Value Engineering For Transportation Improvements

State Road 7 Extension from State Road 704 to Northlake Boulevard PD& E Study

Value Engineering Study Final Report

FM Number: 229664-2-22-01

RECOMMENDATION No. 3: Provide a pervious shared-use path on east side of roadway instead of the standard sidewalks from 60th St to Northlake Blvd.

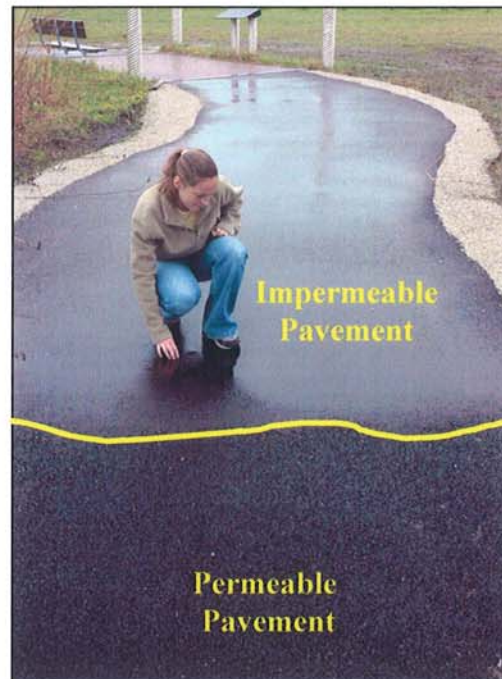
The PD&E Documents show an urban 4-lane divided typical section with 4-foot bike lanes and 6-foot wide sidewalks on both sides of the roadway from Okeechobee Blvd to Northlake Blvd. The bike lanes and sidewalks are proposed along the entire corridor with the exception of the proposed bridge across the M-Canal. The bridge typical section includes a 10-foot wide shoulder and 5-foot wide sidewalk on both sides of the bridge.

The VE Alternative is to provide a pervious shared-use path instead of the standard sidewalk on both sides of the roadway from 60th St to Northlake Blvd. It is also suggested that a sidewalk be provided on the west side of the roadway between the Ibis entrance (roundabout) and Northlake Blvd.

Bike lanes will still be provided as part of the typical section. The shared-use path would be a minimum of 12-foot wide and constructed with a pervious material. The type of material and the location (east of the roadway) of the shared-use path should be determined in coordination with the final roadway alignment. Access to the shared-use path will be provided at signalized/roundabout intersections along the corridor.

Response: **Agree** – A shared use path will be included in the project along the east side of the roadway from 60th Street to Northlake Boulevard. In addition, sidewalk will be provided along the west side from the Ibis entrance to Northlake Boulevard.

The Plans Preparation Manual (PPM) allows sidewalk on one side only under the condition that the road parallels a drainage canal and pedestrians are not expected. In the case of the SR 7 project, a portion of the project would parallel the M-Canal and the area between 60th Street to the Ibis entrance will remain undeveloped due to adjacent natural preserves. A shared use path would be able to accommodate the number of expected pedestrians and recreational bicyclists within this segment since as it would provide a linkage between the network of trails planned by Palm Beach County.

RECOMMENDATION No. 11: Construct roundabouts instead of T-intersection

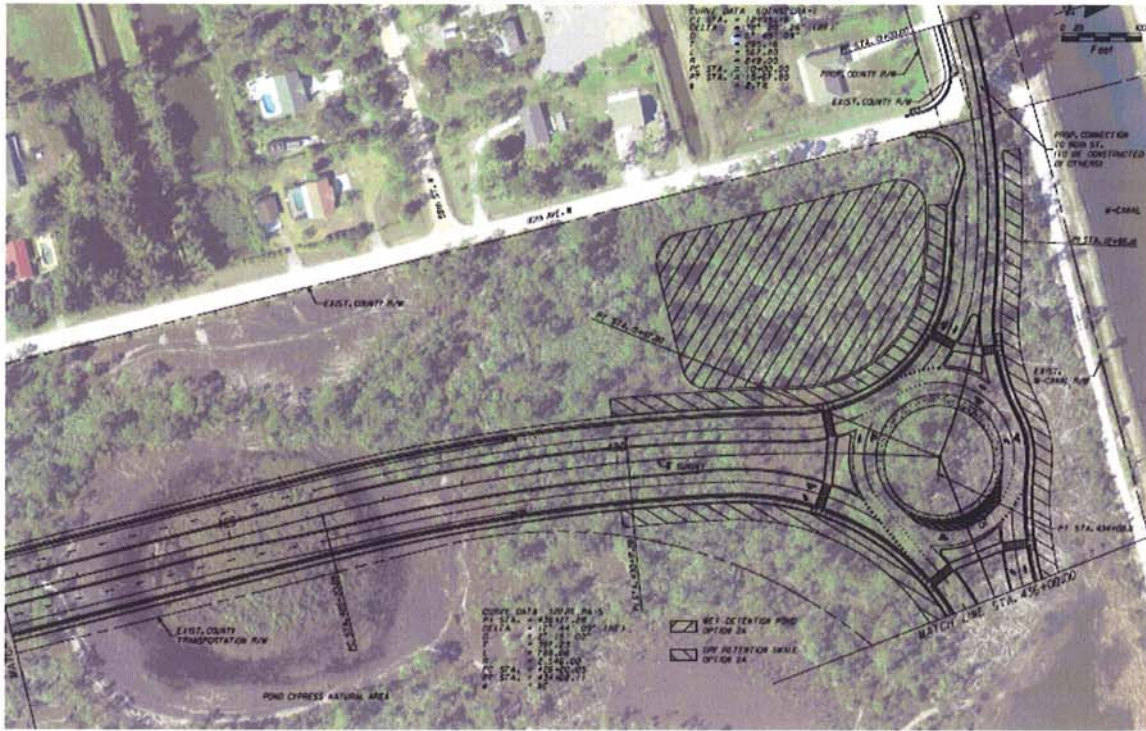
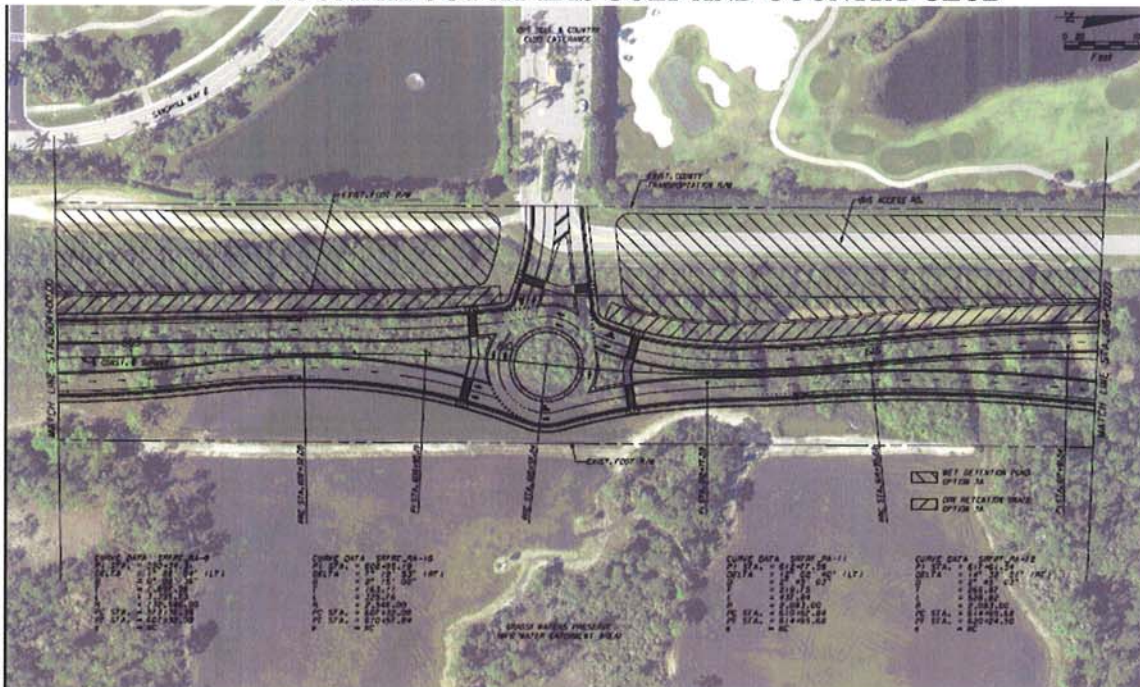
The PD&E Documents show two alternates at intersections for both alignments. One has T intersections with signals and one has roundabouts at 60th Avenue and at the entrance to Ibis Golf & Country Club community.

Response: **Disagree** – The option of a roundabout is already being considered as a part of the PD&E study. Both the roundabout and T-intersection option will be carried through the Public Hearing. Afterwards, the preferred alternative will be selected.

RECOMMENDATION No. 13: Build the east alignment on the northern leg with a swale and environmental berm on the east side of the roadway

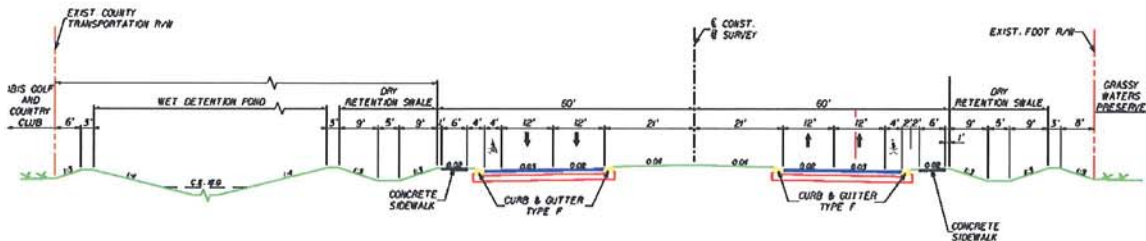
The PD&E documents currently do not indicate that there is a preferred alignment alternative for this section of the SR-7 extension, north of the “M” canal and north of the section of proposed north-south roadway parallel to the Ibis Preserve (which has to be mostly east because of geometric constraints). The PD&E exhibits currently show just two alignment options for this 2.65 mile segment of the corridor; we’re simply calling them the “east” and “west” alignment alternatives. The “east” alignment alternative places the proposed roadway closer to the Grassy Waters Preserve and is considered the less environmentally sensitive option. The “west” alignment alternative places the proposed roadway closer to the Ibis Golf and Country Club community, which is currently ardently opposed to the construction of this SR-7 extension project altogether.

The segment limits for this VE recommendation are from Sta. 511+52.64 to Sta. 651+21.04; this exhibit highlights the segment on an aerial:

- Less risk of environmental impacts caused by spills and accidents along the future roadway because the additional swale width would provide a wider buffer between traffic on the roadway and the wetlands of the Grassy Waters Preserve. This benefit should make this option more desirable for the regulatory agencies than the PD&E “east” alignment alternative, which currently shows little to no buffer width between the roadway and the preserve wetlands.

- This VE recommendation would help provide a more uniform typical for the project; the proposed roadway is mostly adjacent to the eastern edge of our right-of-way.

Response: **Disagree** – The VE recommendation of shifting the east alignment 19 feet to the west would provide a greater separation between the Grassy Waters Preserve and the roadway. While this recommendation provides several advantages as outlined in the VE Study Report, the ultimate location of the roadway will be determined through public involvement and agency coordination. The PD&E team is currently working with the South Florida Water Management District (SFWMD), the US Army Corps of Engineers (USACE), and other permitting agencies to determine the conditions necessary to meet all permit requirements for the construction of the roadway. An east, west, and middle alignment option will be carried through the Public Hearing for final consideration.

RECOMMENDATION No. 18: Consider a separate pedestrian bridge with a shared use path

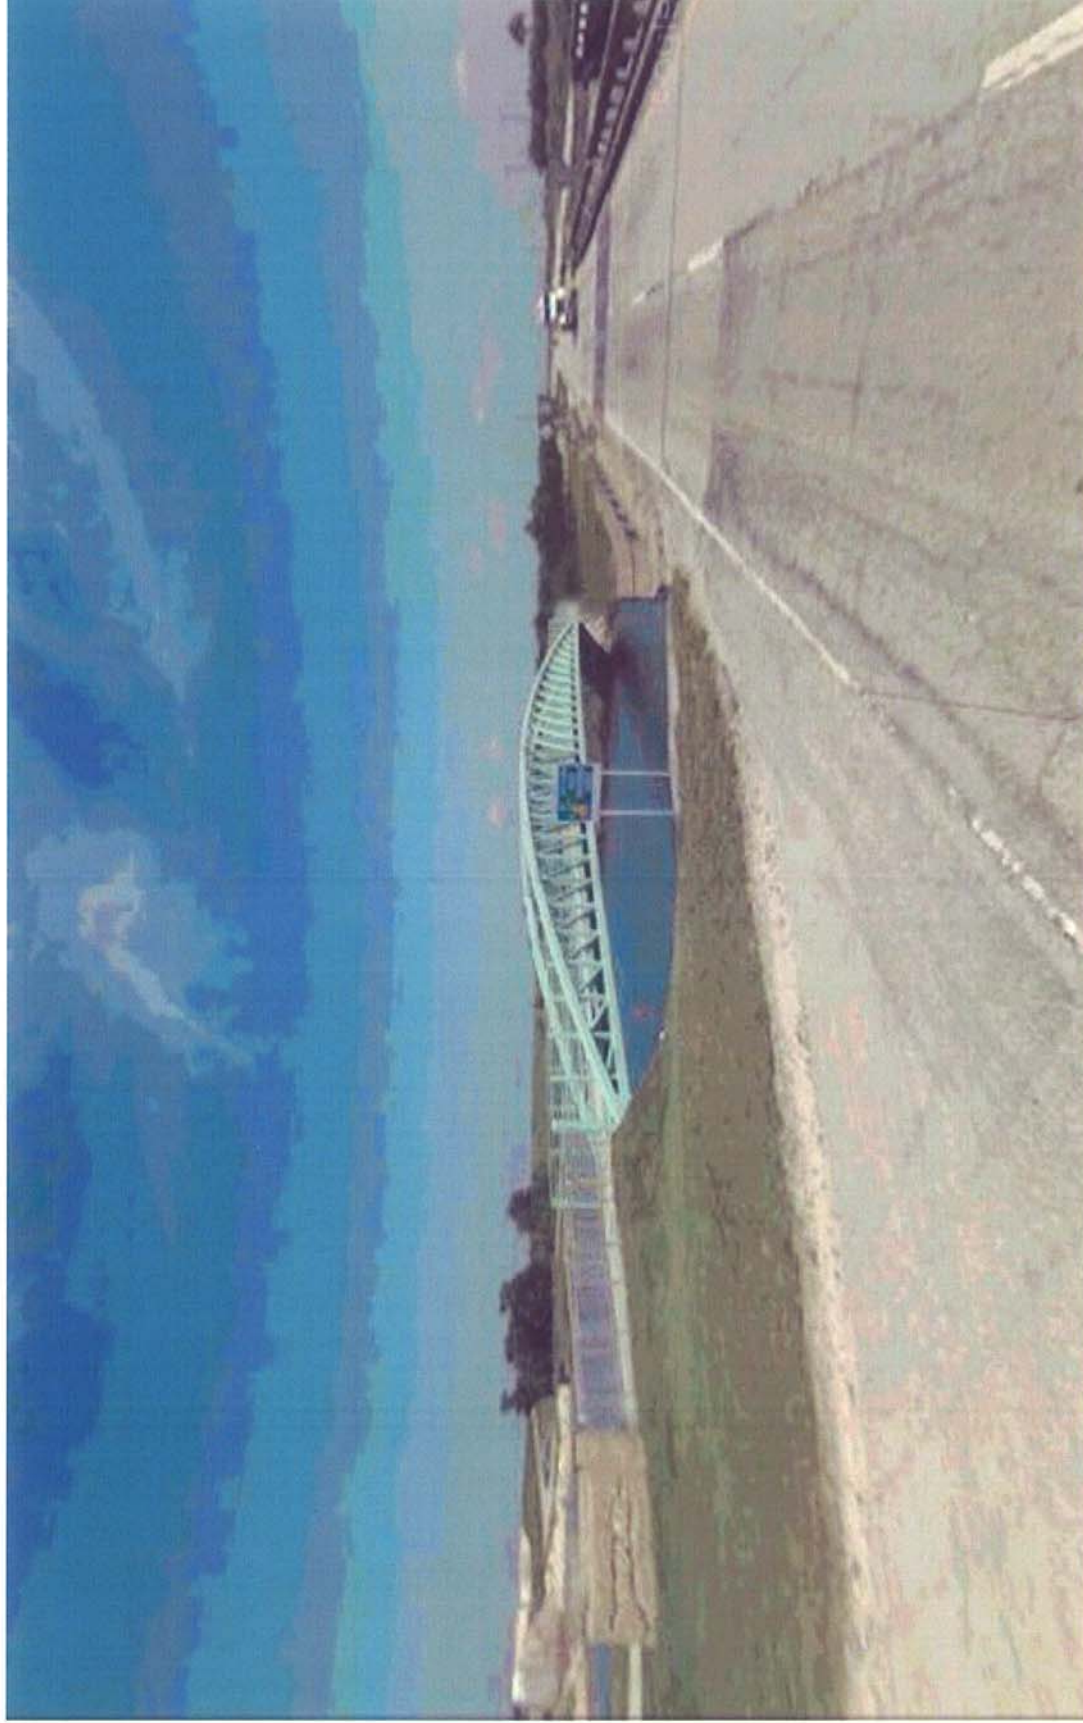
The PD&E Documents show a single bridge structure over the M-Canal for both pedestrian and vehicular traffic. The current design has 5-foot wide sidewalk on both sides of the road. The sidewalks are currently separated from traffic by a 10-foot wide paved shoulder and a 1.5-foot wide concrete barrier.

7. VE Alternative 18: Eliminate the two 5-foot wide sidewalks and replace them with a single separate pedestrian bridge over the M-Canal (Potential added value of \$104,000).

Response: Agree – As discussed under the response for VE Alternative 3, a shared use path will be included within the segment between 60th Street and Northlake Boulevard along the east side of the roadway. The bridge over the M-Canal is located within this segment and providing a single pedestrian bridge provides continuity of the proposed shared use path system.
